WILSON ARCH SPECIAL SERVICE DISTRIC WATER IMPROVEMENTS 2022  
Addendum 1  
January 9, 2024

This Addendum 2 shall become part of the plans, specifications and contract documents of the above-referenced project, and all provisions of the contract shall apply hereto.

WILSON ARCH WATER & SEWER SSD  
WILSON ARCH WATER PROJECT  
2023  
TYPICAL DETAILS

SEI NO.	DESIGNED	DRAWN	CHECKED	SHEET NO.	D1
09132	DS	KL	CS	16

**H** DETAIL - DUMMY WELL  
TYP NTS

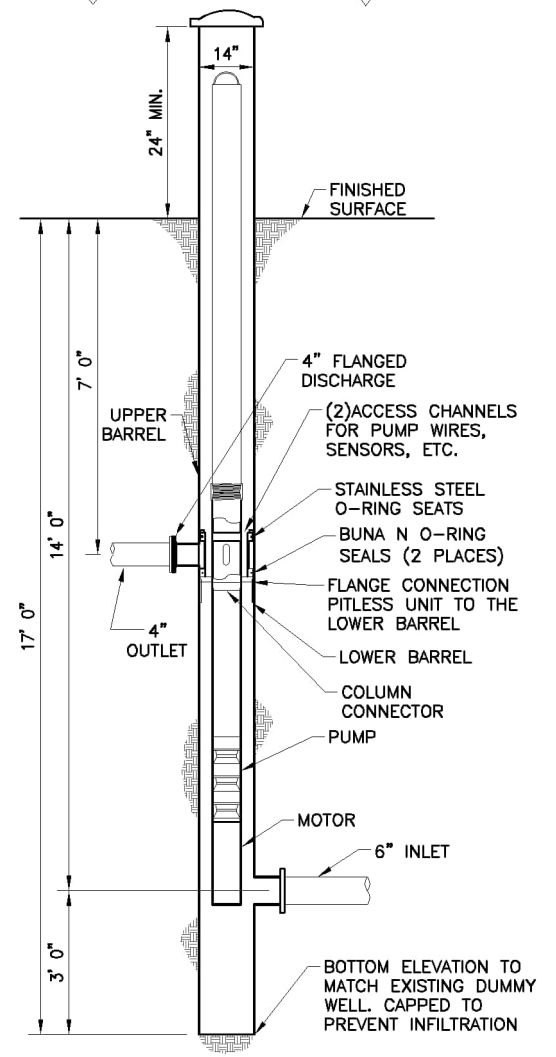
- b. A new detail for the new dummy well has been added to Sheet D1, Detail H
4. Q: Is there any information on the existing booster pump controls?  
A: The existing booster pump control panel at the West Side Pump Station was manufactured by Precision Pumping Systems and installed by Advanced Pump & Equipment. As-built documentations list the installed PLC as an IDEC MicroSmart model FC6A-D16RC1EE. It is the responsibility of the INTEGRATOR to obtain required communication addressing information as required.

**F** DETAIL - BORING UNDER HIGHWAY  
TYP NTS

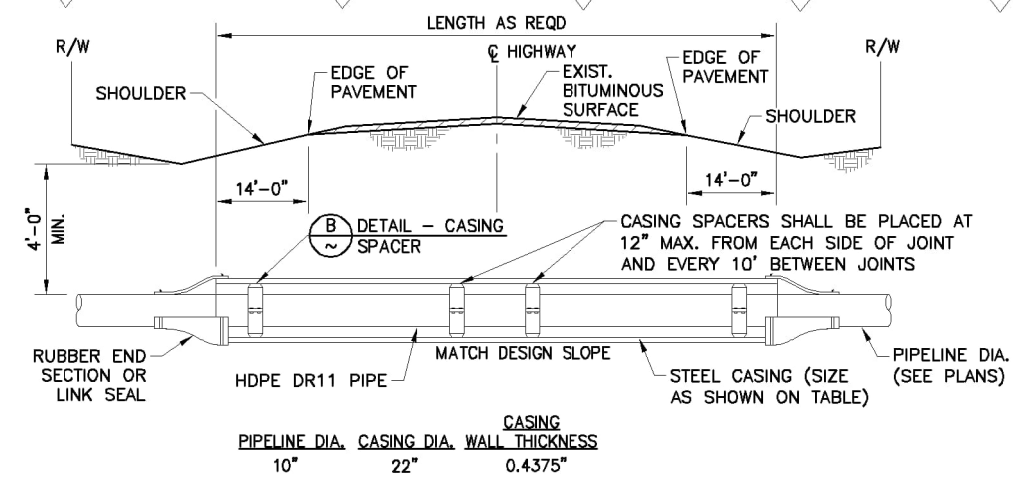
3. Revisions to the Plans:
  - a. Sheet D1, Detail F – Boring Under Highway has been revised. Revisions to the detail include a steel casing being required for the carrier pipe. See Sections 02315 and the revised 02318SP in this Addendum 2 for more information.

**NOTES:**  
1. ALL WORK SHALL COMPLY WITH REQUIREMENTS FOR CONSTRUCTION ON STATE HIGHWAYS.  
2. CONTRACTOR SHALL OBTAIN ENCRANCHMENT PERMIT PRIOR TO CONSTRUCTION.  
3. INSTALL CASING LEVEL AND STRAIGHT WITH NO DENTS OR BENDS. WALL THICKNESS AND MATERIAL SHALL MEET SPECIFICATIONS.  
4. CASING SHALL EXTEND 14FT. BEYOND EDGE OF PAVEMENT.

PIPELINE DIA.	CASING DIA.	WALL THICKNESS
10"	22"	0.4375"
